CITY OF PORTLAND

re: 54 Roberts St.

BUILDING PERMIT REPORT

REASON FOR PERMIT: To make interior renovations
(Attic area and construct deck egress,

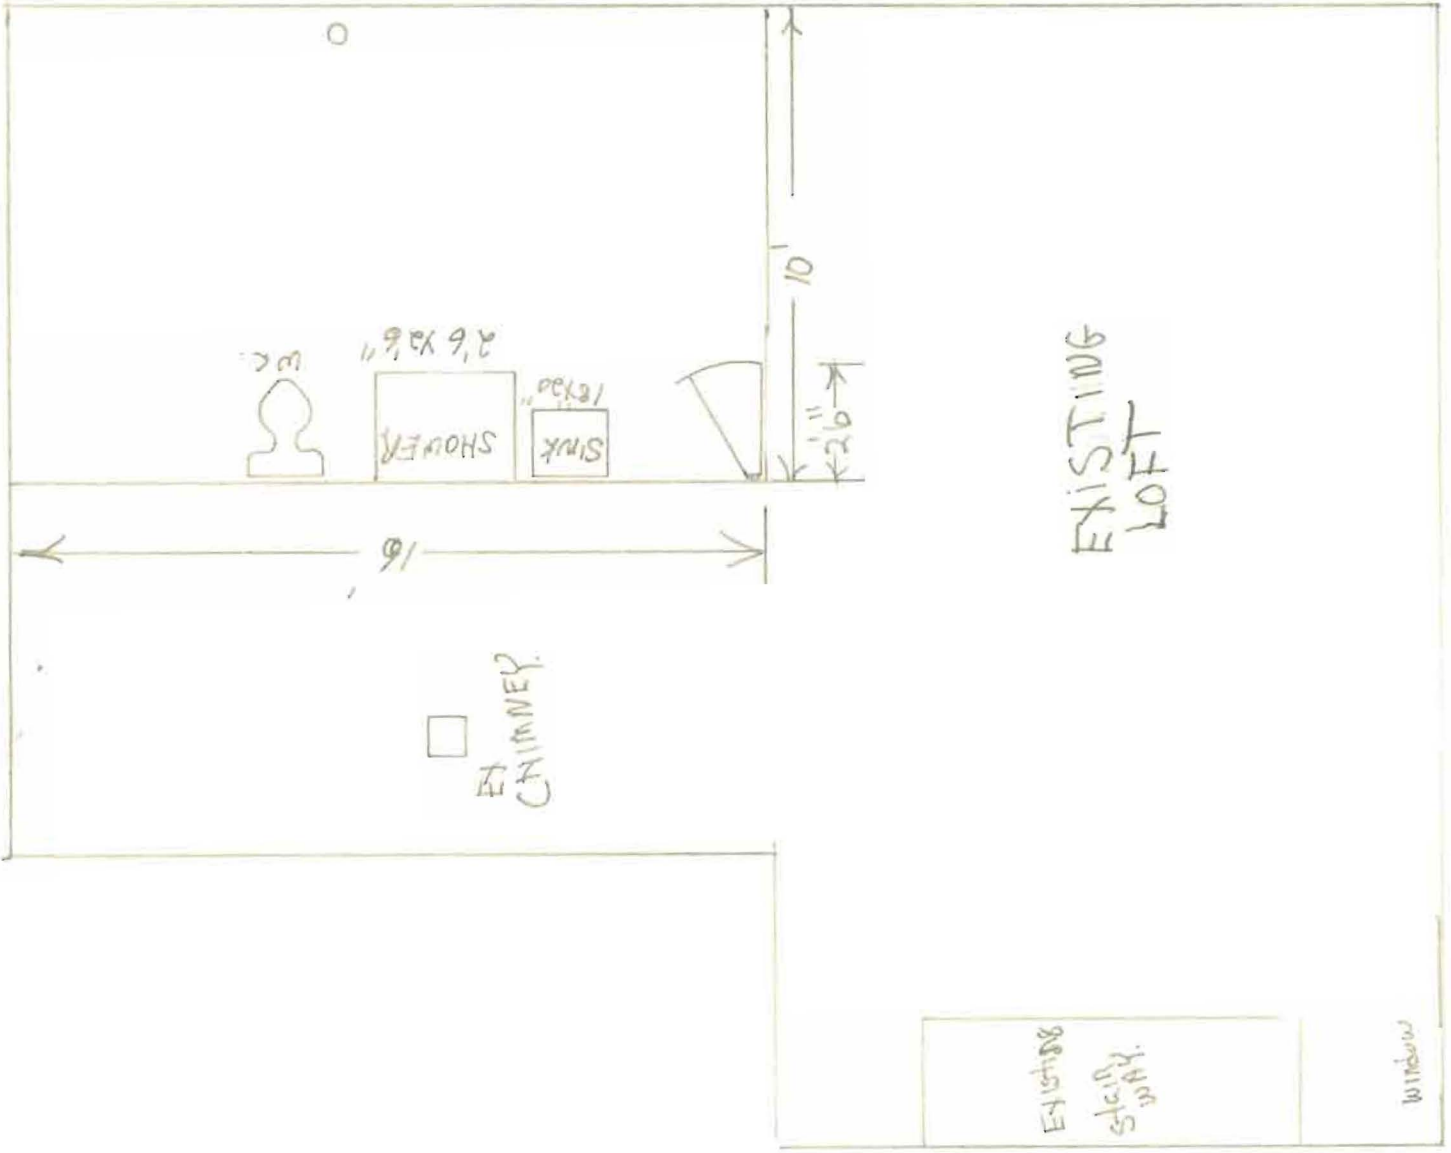
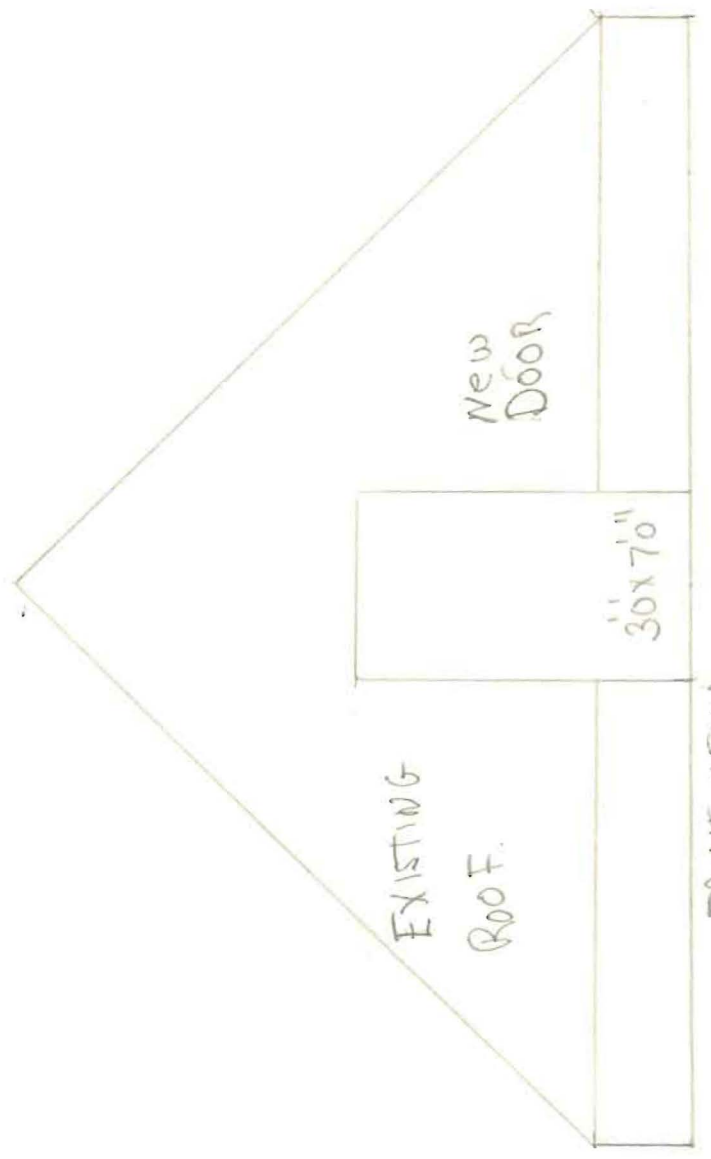
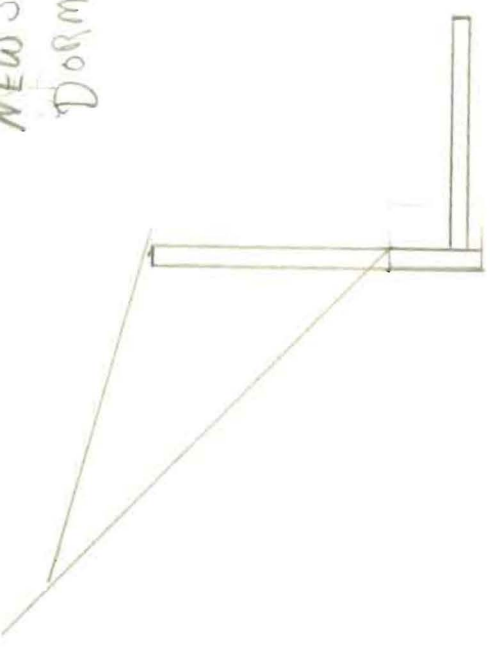
1. This permit is being issued with the understanding there is no increase in the footprint of the building.
2. No kitchen is allowed in the attic. Building is to remain a two(2)-family building.
3. The attic space will have a minimum of one(1)-hour separation wall between the adjoining upstairs of the building.
4. Please read and implement items # 3,4,6,7,9,12,13,14,15.

APPROVED: *3 *4 *6 *7 *9 *12 *13 *14 *15

X 9.) A guardrail system located near the open side of deck or elevated walking surfaces shall be constructed. Guards in buildings of Use Group R-3 shall be not less than 36 inches in height. Open guards shall have intermediate rails, balusters or other construction such that a sphere with a diameter of 4 inches cannot pass through any opening. Handrails on stairs shall be no less than 34 inches nor more than 38 inches. Handrails within individual dwelling units shall not be less than 30 inches nor more than 38 inches. For more detail on guards & handrails see Article 8 section 824.0 and 825.0 of the BOCA National Building Code.

X 13.) Headroom in habitable spaces is a minimum of 7'6".

X 14.) The minimum headroom in all parts of a stairway shall not be less than 6 feet 8 inches.
